Architectural Review  
and Historic Preservation Board  
Agenda Report

Meeting Date 04/20/16

Files: S/PDP 15-04,  
GPA 15-04, RZ 15-03

RE: Design of Single-family Homes for the Estates at Lindo Channel Subdivision  
1511 Manzanita Avenue, APNs 015-520-036 and 015-520-037

**PLANNED DEVELOPMENT SITE PLAN**

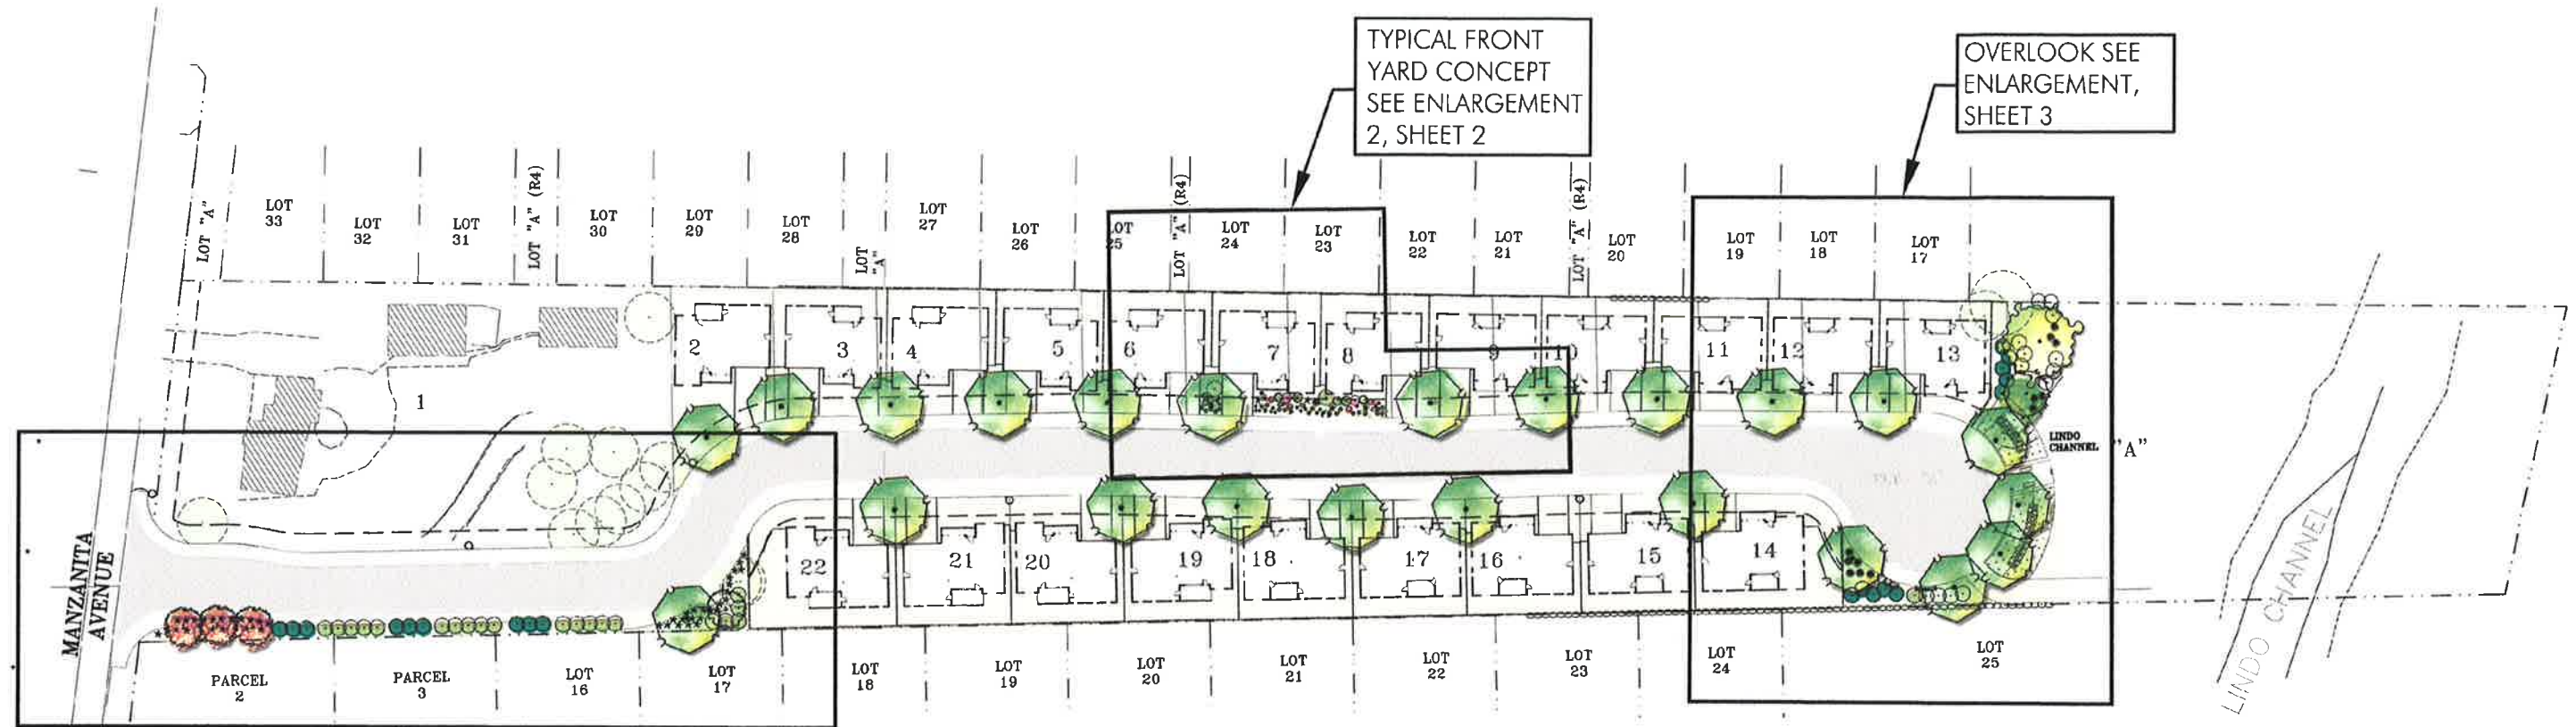
Lot 6 and Lot 14: Small lot setbacks apply to these lots. The requested exception would authorize a minimum front yard setback of 11 feet instead of 12 feet.

Lots 19 and 21: Typical R1 setbacks apply to these lots. The requested exception would authorize a minimum front yard setback of 11 feet instead of 15 feet and a rear yard setback of 10 feet instead of 15 feet.

The proposed homes also include roof projections into side yard setbacks for the eaves, which would be two feet from the property line instead of three feet, as required by the municipal code.

The requested reductions in setbacks are relatively minor for a small-lot subdivision and staff supports inclusion of the home design with smaller porch to add variety to the new streetscape.

- a. Eleven-foot front yard setbacks
  - b. Ten-foot rear yard setbacks
  - c. Building projections into side yard setbacks, as shown on the elevation drawings.

PLAN A1-A - 1368 SQ. FT.

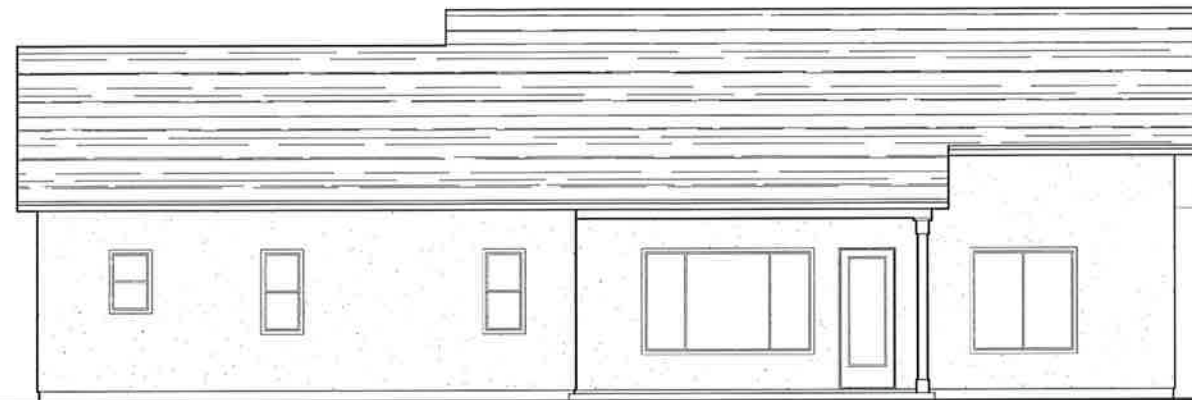
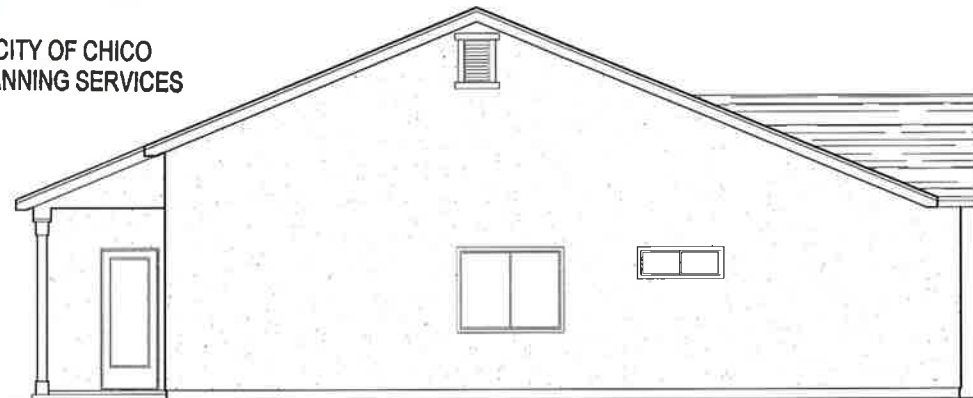
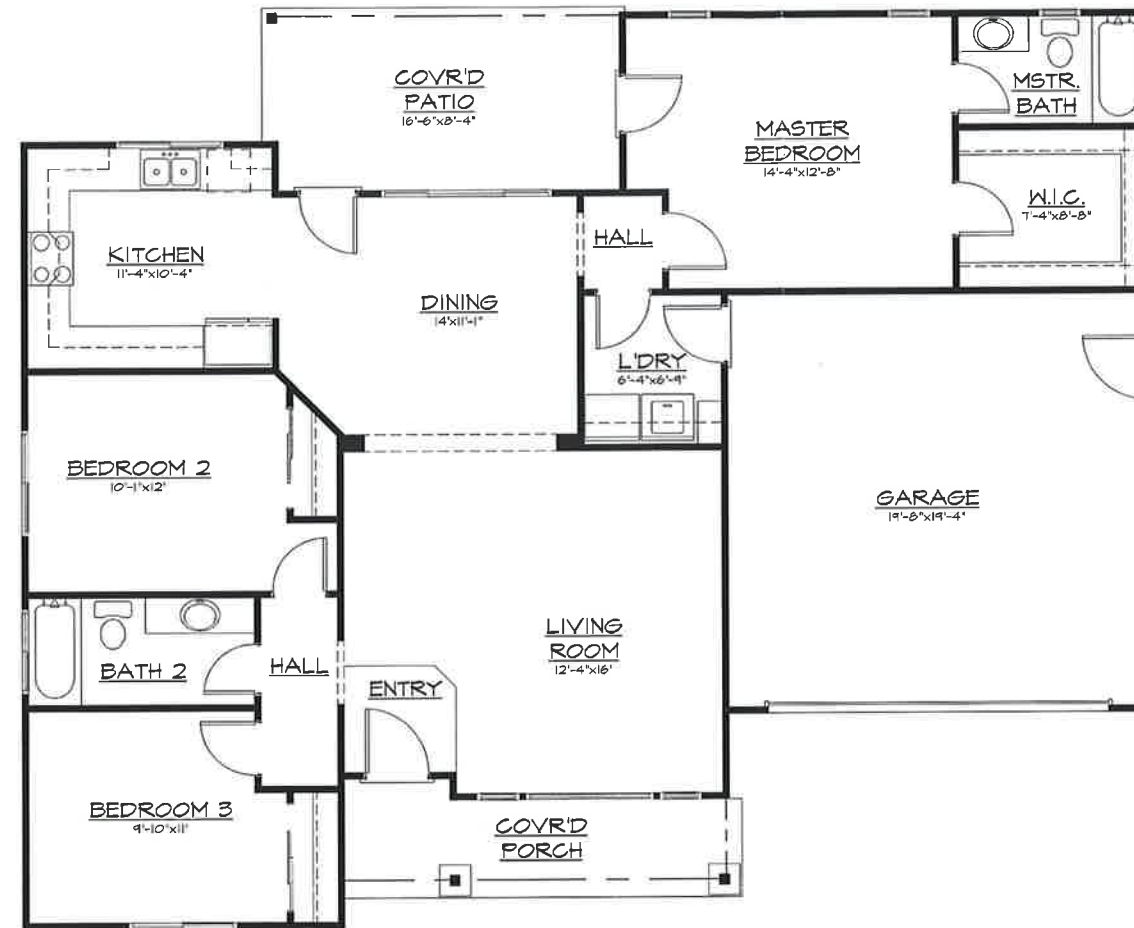
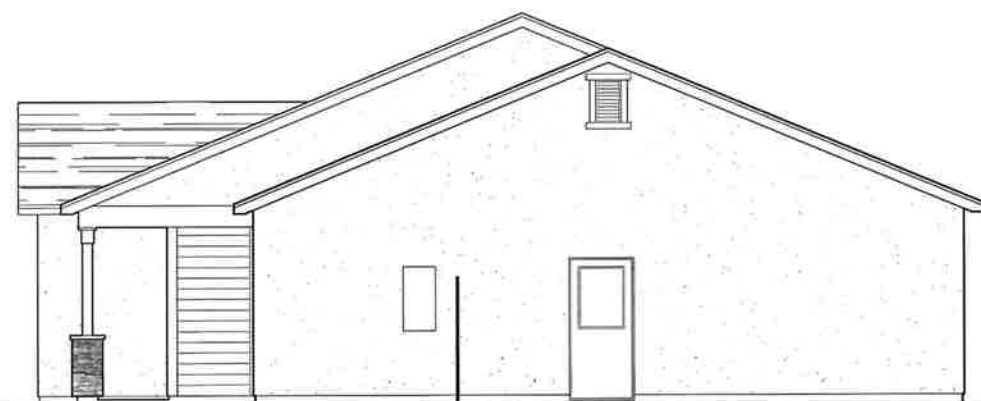
The proposed architecture features higher-quality design elements on the front elevations, such as raised/painted window trim, window grid-dividers, lap siding and decorative rock, that are not carried around to side or rear elevations. A required finding for recommending approval of the project is that the *“architectural design of structures, including all elevations, materials and colors are visually compatible with surrounding development,”* and it is part of the stated purpose of Planned Developments in the code to *“promote development in the community which, while deviating from normal development standards, has been demonstrated to be **of greater quality or community benefit** than might occur with a conventional development proposal.”*

To provide consistency with the code language above, recommended conditions would require high-quality design elements on the side and rear elevations of the future residences, as well as enhanced fencing details (battens and trim with two-inch dimensional cap) within the project.

4. The developer shall provide raised trim around all exterior windows and door frames matching the same trim elements shown on the front elevations, and shall use colored vinyl window frames (not white) which complement the color scheme of the residence.

5. The developer shall provide a wainscot on all four elevations of each home using either cement board lap siding or stucco stone, matching the material shown on the front elevations.

CITY OF CHICO		STANDARD PLAN	
DRAWN BY <u>JG</u>	DATE <u>OCT., 1998</u>	STREET LIGHTS POLE AND MAST ARM DETAIL	NO. <b>SL-1</b>
CHECKED <u>RB</u>	SCALE <u>N.T.S.</u>		
APPROVED <u>[Signature]</u>	DIRECTOR OF PUBLIC WORKS	R.C.E. NO.	SHEET 1 OF 11

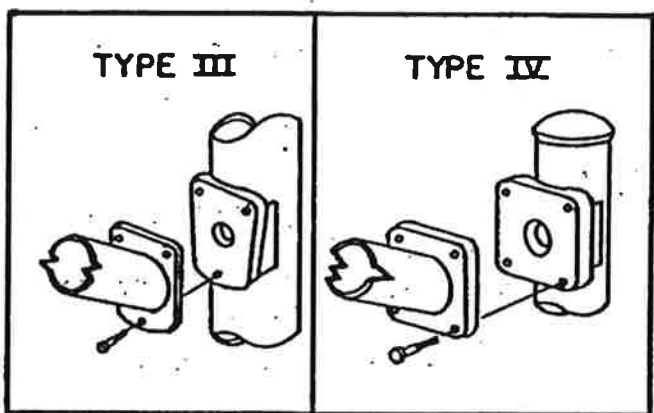
The proposed street lighting would place a new 30-foot tall street light with six foot mast arm approximately 12 feet from a neighboring residential rear yard near the grouped mailboxes at the end of the cul-de-sac, and on the east side of the new street near the entry to the project, approximately 45 feet from other rear yards of existing neighboring residences.

Provided DGs that discourage new lighting that could result in glare impacts to off-site residents and light spillage into natural open space areas (DGs 4.2.44 and 1.5.19, respectively), a condition is recommended to require that street lighting be provided with 18-foot City-standard street lighting to minimize light spillage impacts to neighboring residences and Lindo Channel open space area. The 18-foot light standards are provided on page 7 of 11, under **Attachment J**.
